**CONTINUING ELIGIBILITY INSPECTION (CEI) REPORT**  
***FOR FLOOD CONTROL PROJECTS***

1. Project Name: Namo River FCP
2. Date of Inspection: February 6, 2002

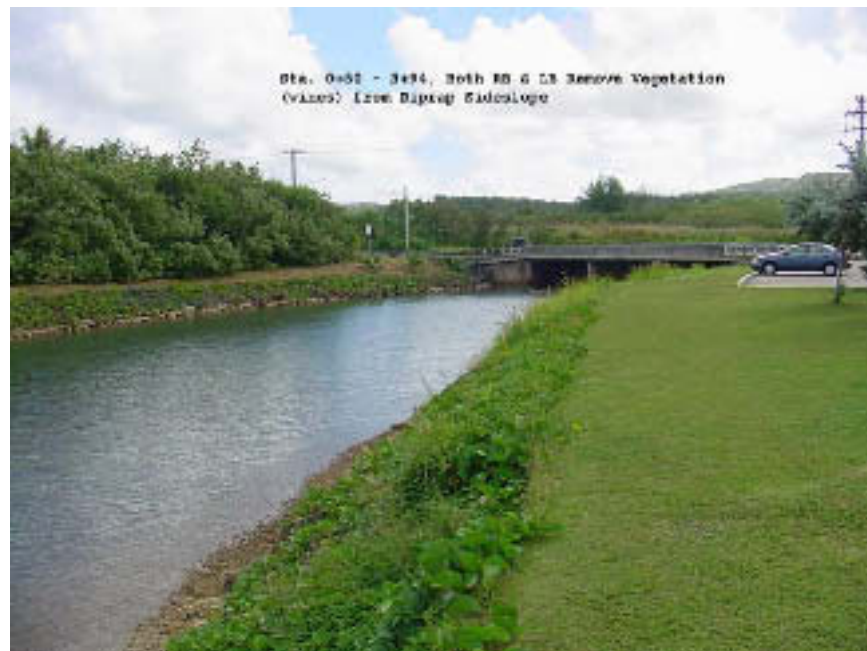
a. Sta. 0+50, Right Bank (RB), remove vegetation from riprap slope protection.

b. Sta. 0+50 - 3+95, Right Bank & Left Bank, (LB), remove vegetation from riprap slope protection.

c. Sta. 2+00, Left Bank, (LB), remove vegetation from riprap slope protection, unable to verify riprap placement.

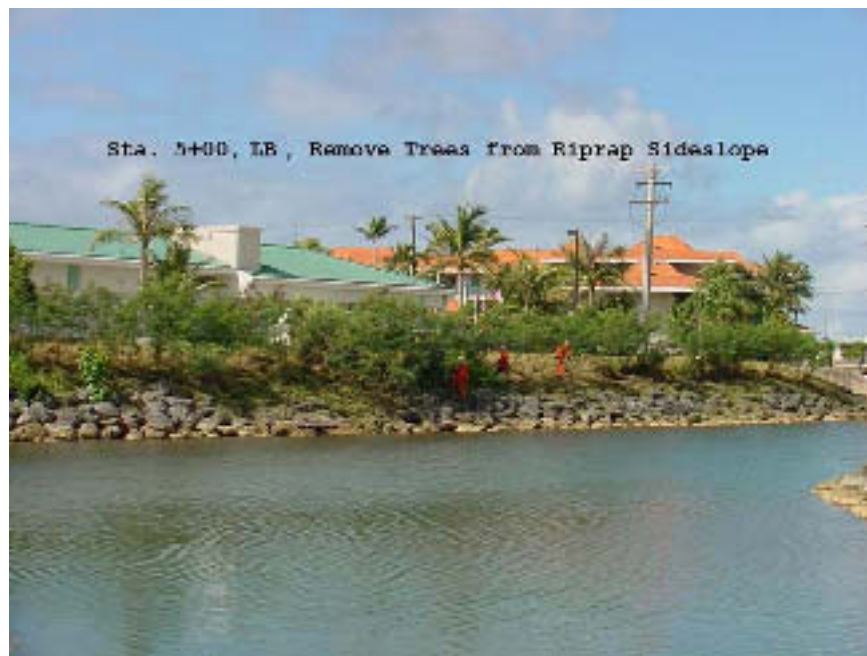
d. Sta. 4+55, RB, remove vegetation from levee and riprap slope protection, unable to verify riprap placement (DPW workers initial effort).

e. Sta. 4+55, RB, remove vegetation from levee and riprap slope protection, unable to verify riprap placement.

f. Sta. 5+00, RB, remove vegetation from levee and riprap slope protection, unable to verify riprap placement.

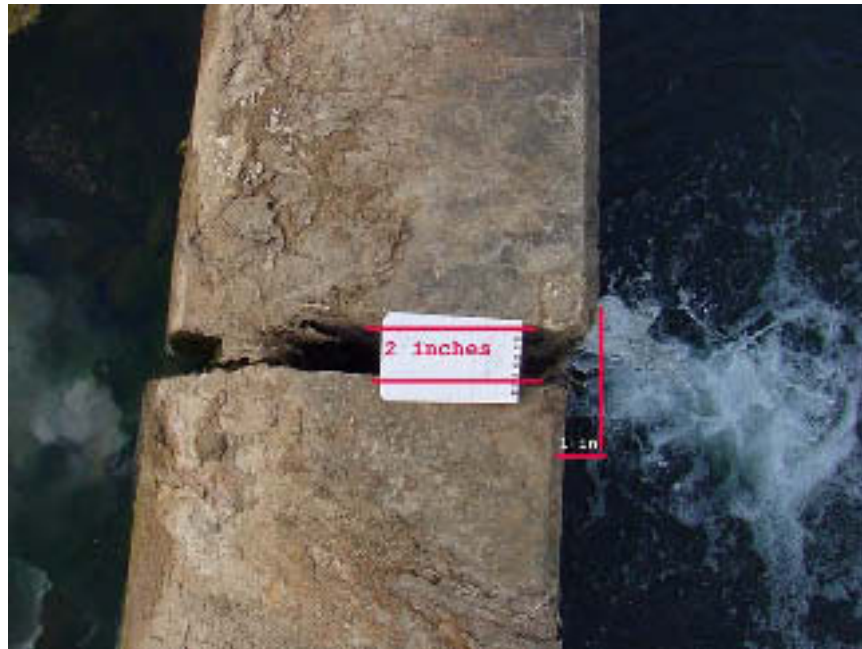
- i. Sta. 13+06, LB, remove vegetation from levee, weir headwalls, fence and riprap slope protection, unable to verify riprap placement.

- j. Sta. 13+06, RB, remove vegetation from levee, weir headwalls, fence and riprap slope protection, unable to verify riprap placement.

k. Sta. 13+66, Weir, monitor weir gap, the gap has increased .5 inches since the last inspection. (possible cause recent earthquakes).

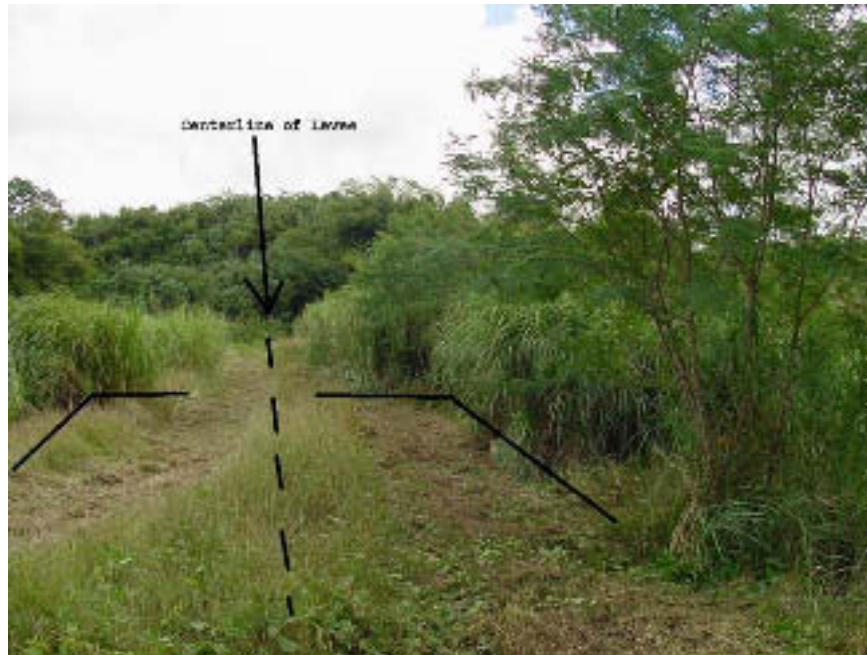
o. Sta. 14+25, RB & LB, remove vegetation from levee and riprap slope protection, unable to verify riprap placement.

p. Sta. 15+50, LB, Facing downstream, remove vegetation from levee and riprap slope protection, unable to verify riprap placement. (Grass cut on crest during inspection).

q. Sta. 17+00, RB, remove old excavated material stockpile from levee, continue to re-establish levee crest.

r. Sta. 0+00 - 4+00, Levee, remove all woody vegetation and cut grass on levee sideslopes.
